United States Holocaust Memorial Museum
Accessibility Assessment
Summary Report

Project Coordinator
Michael Zisk, Museum Architect

United States Holocaust Memorial Museum
Accessibility Assessment Summary Report
Assessment Date: March 1-2, 2011

DEPORTATIONS

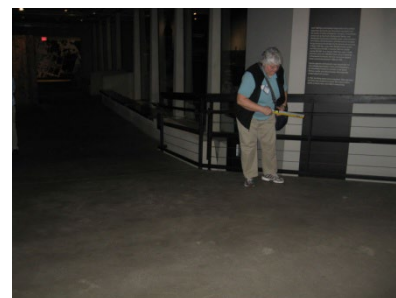
The railcar has a wall of photos alongside it.

Recommendation: Provide audio description of the photos in an audio description tour.

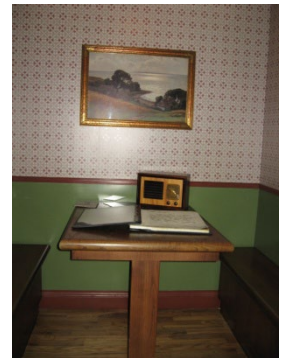
The small table in the “dining table” area that holds Daniel’s diary does not have knee and toe clearance for a forward approach for a wheelchair.

Recommendation: Reposition the table to allow for a forward approach.
